**“SAFETY RECALL NOTICE”**  
**NATIONAL HIGHWAY TRAFFIC SAFETY ADMINISTRATION**  
**RECALL NO: 15E013**

**RV QUAD STEP 24" x 8 x 8, RIVET REPLACEMENT**

REV.B032715

**HINGE POINT RIVET MARKED #96 @ 2<sup>nd</sup> & 3<sup>rd</sup> STEP**

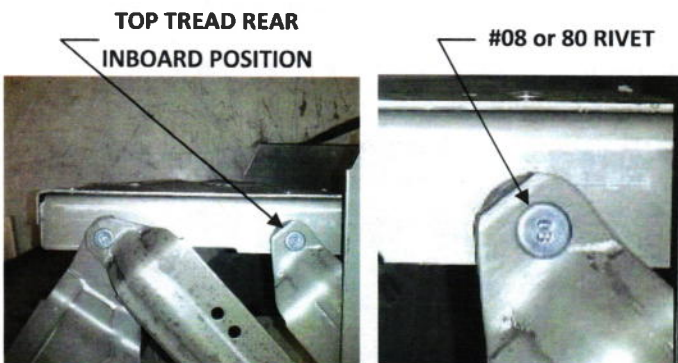
5.1.1 This configuration has a hinge point rivet marked with the #96 at the 2<sup>nd</sup> & 3<sup>rd</sup> Step (2<sup>nd</sup> & 3<sup>rd</sup> step, defined as the 2<sup>nd</sup> step from the ground level and the 3<sup>rd</sup> step from the ground level).

5.1.2 And a Top Tread mount point rivet marked with the # 08 or 80 at the rear inboard mounting position, both left and right sides.

**NOTE: CONFIGURATION "A" - MUST BE REPAIRED IN ACCORDANCE WITH SRP-APPENDIX "A" .**

**HINGE POINT RIVET MARKED #55 @ 2<sup>nd</sup> & 3<sup>rd</sup> STEP**

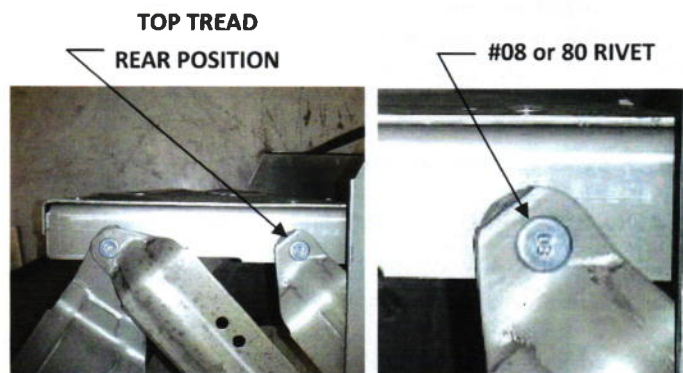
5.2.1 This configuration has a hinge point rivet marked with the #55 at the 2<sup>nd</sup> & 3<sup>rd</sup> Step (2<sup>nd</sup> & 3<sup>rd</sup> step, defined as the 2<sup>nd</sup> step from the ground level and the 3<sup>rd</sup> step from the ground level).

5.2.2 And a Top Tread mount point rivet marked with the # 08 or 80 at the rear inboard mounting position, both left and right sides.

**NOTE: CONFIGURATION "B" - MUST BE REPAIRED IN ACCORDANCE WITH SRP-APPENDIX "B" .**

## ENLARGE HOLE

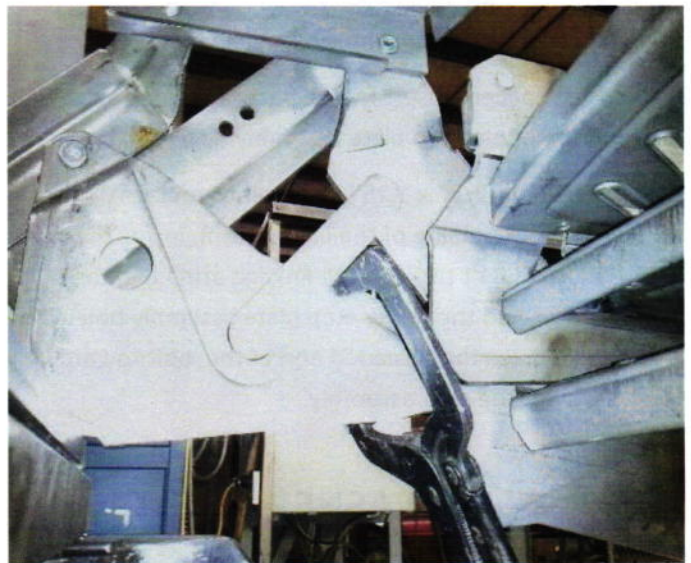
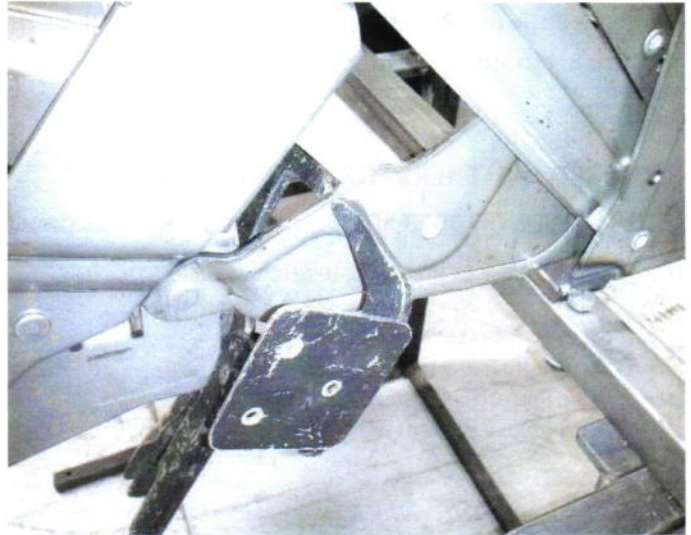
7.3 Enlarge hole of step plate assembly using a 3/8” drill bit. The linkage arm can be used as a guide by lifting up steps with one hand to line up holes of linkage arm and step plate assembly.

### **REQUIRED FASTENERS FOR THE TOP STEP TREAD MOUNT - # 08/80 RIVET KIT**

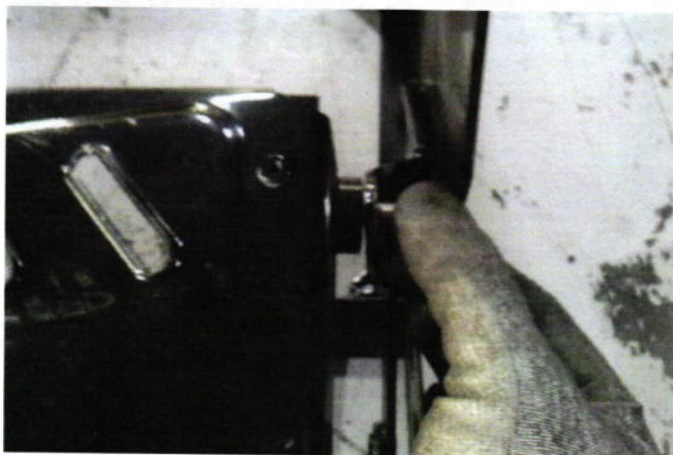
8.3 Insert Bolt (3/8" x 1.25" long bolt to replace 08 or 80 rivet) - From outside of the linkage arm, insert the 3/8" Hex Head Bolt through the linkage arm hole, the Nylon Spacer and the upper step plate assembly hole. This should place the threaded end of the bolt toward the interior of the step assembly.

### **INSTALL FLAT WASHER / NUT**

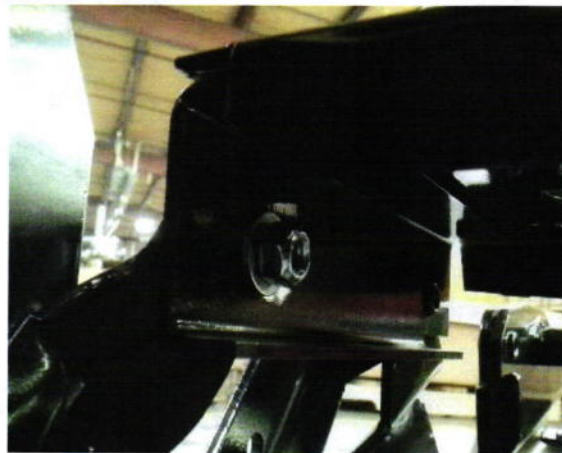
8.4 Install Flat Washer and Lock Nut - Install the 3/8" Flat Washer and 3/8" Stover Nut onto the end of the 3/8" Hex Head Bolt.

**NOTE: Tighten the Stover Nut to 12-16 ft. lbs. of torque for proper step operation.**

## ENLARGE HOLE

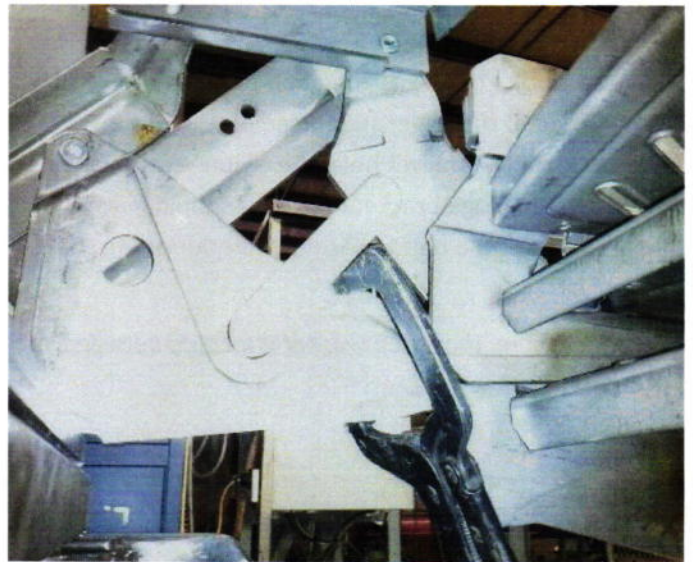
7.3 Enlarge hole of step plate assembly using a 3/8” drill bit. The linkage arm can be used as a guide by lifting up steps with one hand to line up holes of linkage arm and step plate assembly.

### **REQUIRED FASTENERS FOR THE TOP STEP TREAD MOUNT - TOP STEP HARDWARE REQ'D: # 08/80 RIVET KIT**

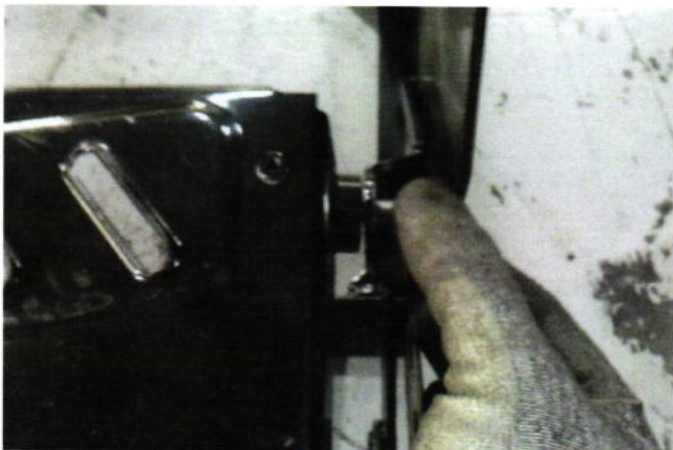
8.3 Insert Bolt (3/8" x 1.25" long bolt to replace 08 rivet) - From outside of the linkage arm, insert the 3/8" Hex Head Bolt through the linkage arm hole, the Nylon Spacer and the upper step plate assembly hole. This should place the threaded end of the bolt toward the interior of the step assembly.
